## BUILDING PERMIT

Permit Number: 100573

has permission to Build a 3 bedrooms, 3 bath, and 557 sq ft garage single Family Home

AT 71 ST LAWRENCE ST CE 016 E023001

**BUILDING SETBACK CALCULATIONS:**

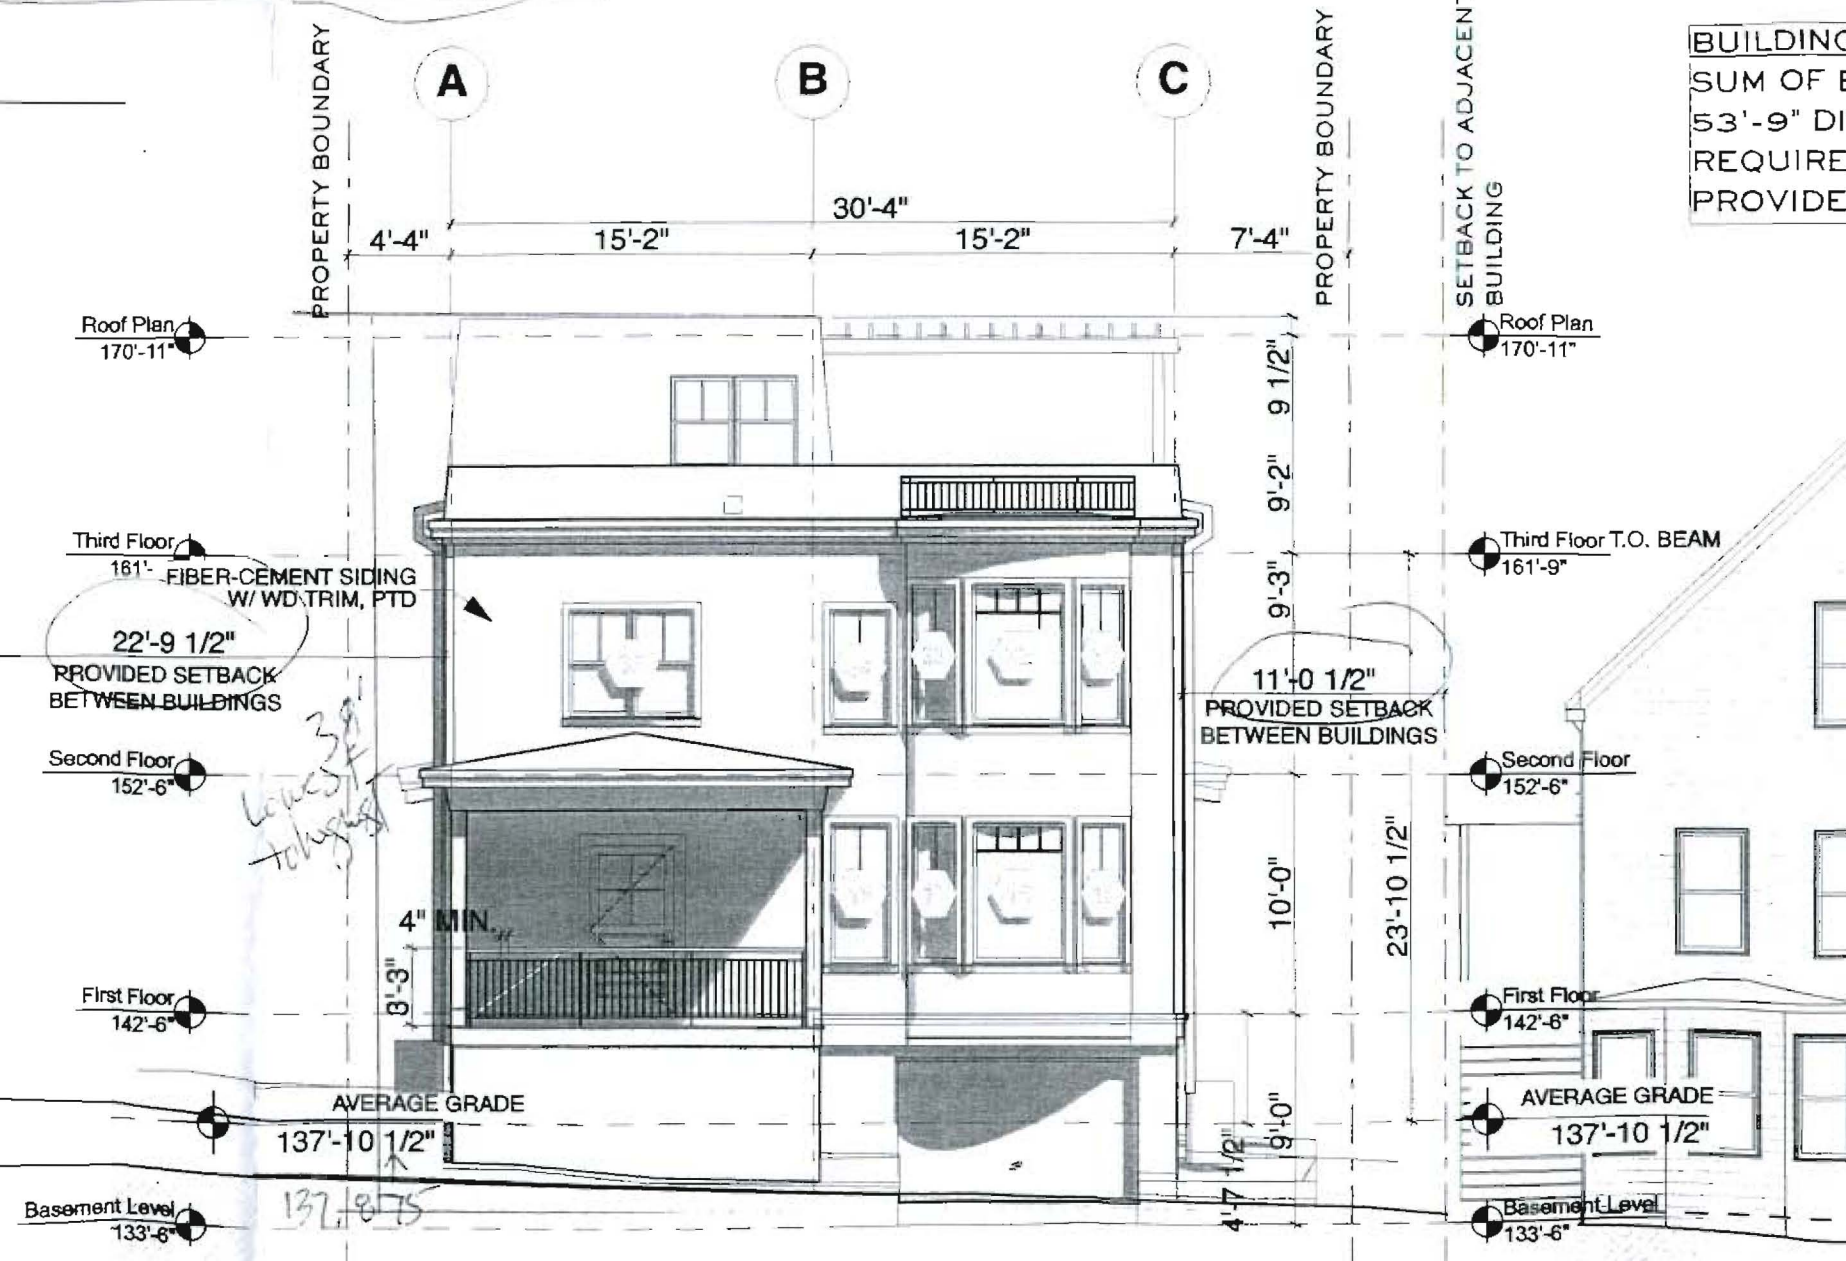
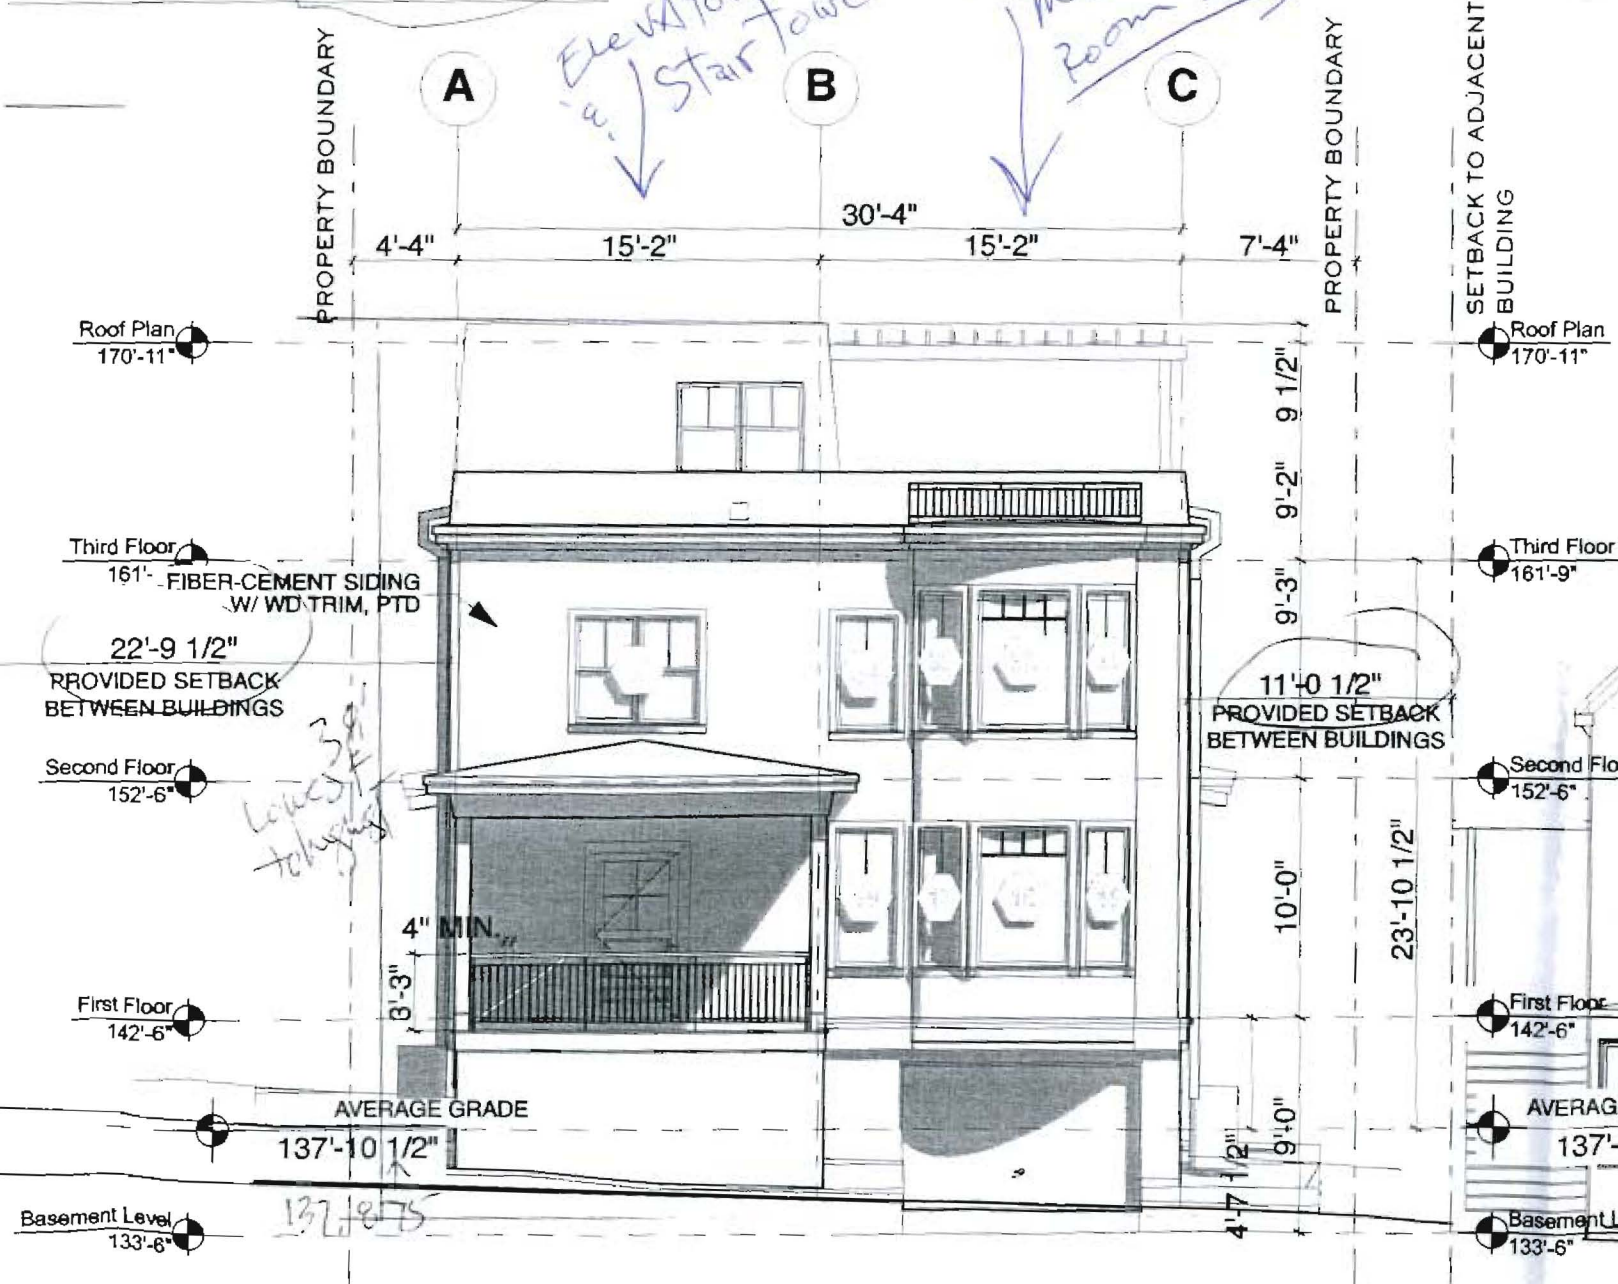
Jesse,  
 thank you for the plans you brought in today. Can you further explain the setbacks between buildings? You have shown 23'11" as the height if the big. The building is actually higher at 33' 1/2". Why wasn't that dimension used for the comparison building setback?  
 Thank you,  
 Marge

I did receive the calculations concerning building height. The methodology for figuring the average grade is sound. I am not completely understanding where the average grade is being measured to. On flat roofs, the Ordinance directs the measurement to be to the top of the roof beam. The plans measure to "roof plan". I need some explanation as to what "roof plan" refers to.

SUM OF BUILDING HEIGHTS: 23'-11" + 45'-0" = 68'-11"  
 68'-11" DIVIDED BY 5 = 13'-9 1/2"  
 REQUIRED SETBACK BETWEEN BUILDINGS IS 13'-9 1/2"  
 PROVIDED SETBACK IS 22'-9 1/2"  
 REQUIRED SETBACK TO LOT LINE IS 4'-0"  
 PROVIDED SETBACK TO LOT LINE IS 4'-4"

**BUILDING SETBACK CALCULATIONS:**  
 SUM OF BUILDING HEIGHTS: 23'-11" + 29'-10" = 53'-9"  
 53'-9" DIVIDED BY 5 = 10'-9"  
 REQUIRED SETBACK BETWEEN BUILDINGS IS 10'-9"  
 PROVIDED SETBACK IS 11'-0 1/2"
